PREVOST

Instruction Sheet

IS-97133

H3-41 & H3-45 COACH SEDAN DOOR OPERATION SYSTEM VALVE REPLACEMENT.

FIGURE 3: DISCONNECTION FOR REMOVING THE MOUNTING PLATE.

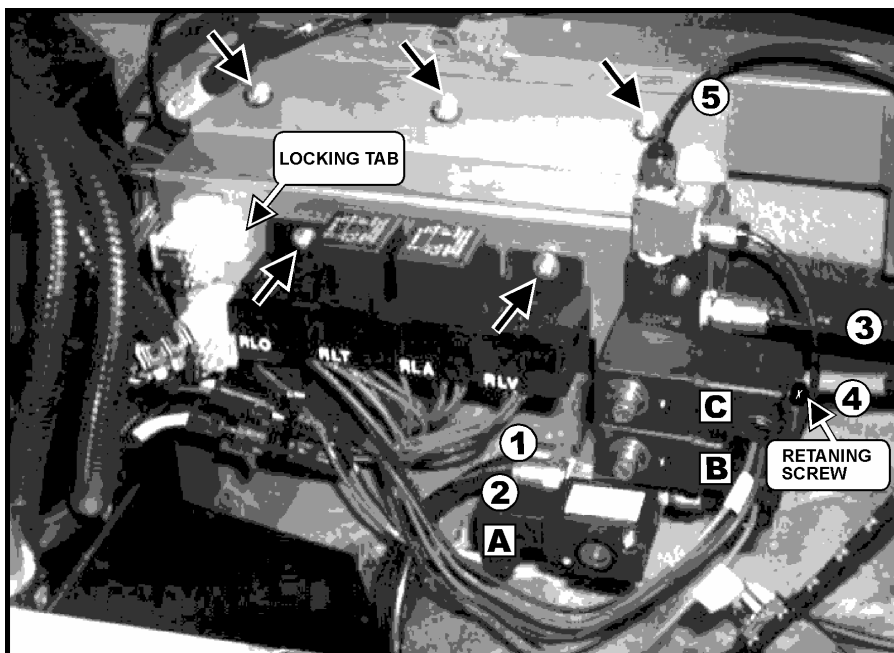
-
4. Label all the pressure hoses as indicated (1 to 5) on figure #3. Disconnect all these hoses by pressing the fitting ring while pulling out the hose for every connection.
 5. Label all the solenoid connections as indicated (A,B,C) on figure #3. Unscrew the retaining screws on the top of each connection using a Phillips #1 short screwdriver and disconnect all these connections.
 6. Unscrew the relay row two (2) mounting screws taking care not to drop them in the compartment (Fig 3).
 7. With the help of a flat-tipped long screwdriver, push the white plugs locking tabs through the mounting plate in order to extract them from the mounting plate (Fig. 3).
 8. Remove the mounting plate three (3) retaining screws, always taking care not to drop them and then take the mounting plate out of the compartment (Fig. 3).

FIGURE 4: VALVE DISMOUNTING.

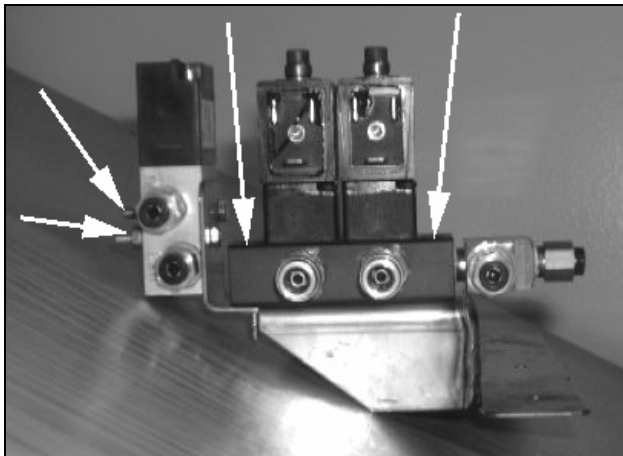
9. Unscrew the existing 2-valve manifold assembly. Remove the *Humphrey* valve two (2) mounting nuts and screws (Fig. 4).
10. With the help of a pair of pliers and a hammer, straighten the mounting plate folded part originally made for the *Humphrey* valve mounting. Also, every welding spill out over the new manifold assembly mounting surface must be flat ground. These procedures are necessary prior to install the new *NORGREN* 4-valve manifold assembly provided in kit #285921.

FIGURE 6: PROPER CONNECTIONS ON THE NEW MANIFOLD ASSEMBLY.

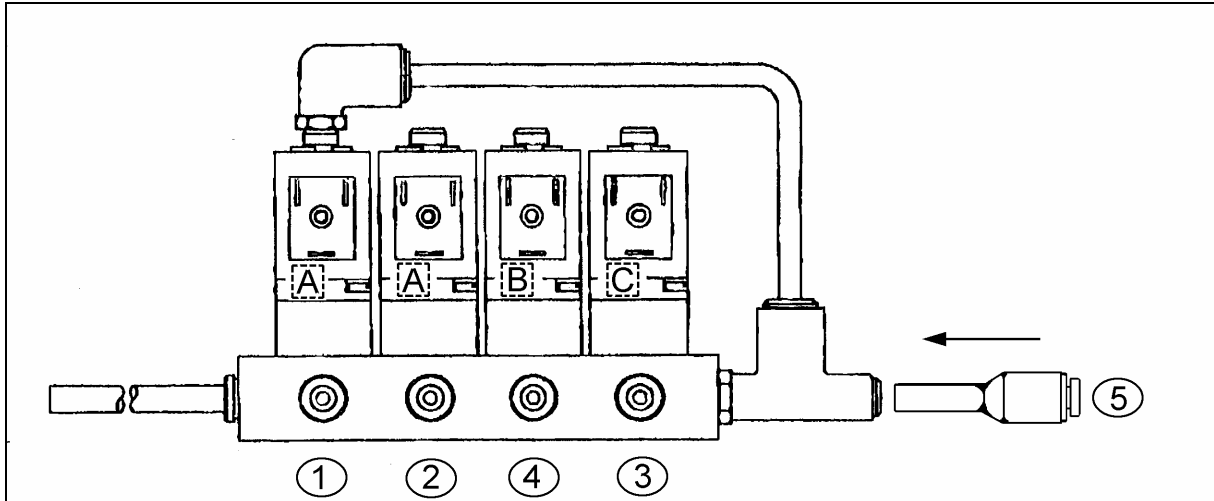
13. Install the #691455 reducer on the new manifold assembly as indicated on figure #6.
14. Take the relay row, the two white plugs and the solenoid plugs out of the compartment prior to working on the connections. Cable ties cutting out and two leads connector (C279) disconnection is needed to pull out the relay row.

-
18. Install the two white plugs through the mounting plate and secure the mounting plate with the three (3) original screws.
 19. Connect the air pressure hose and solenoid plugs with their retaining screws following the indications illustrated on figure #6.
 20. Secure the relay row with the two original screws and reinstall the two relays removed previously.
 21. Set the sedan door system in operating order by turning back the "Emergency Door Unlatch" valve in the vehicle front service compartment before proceeding to a sedan door operation test. After this test, the finishing panel can then be installed.
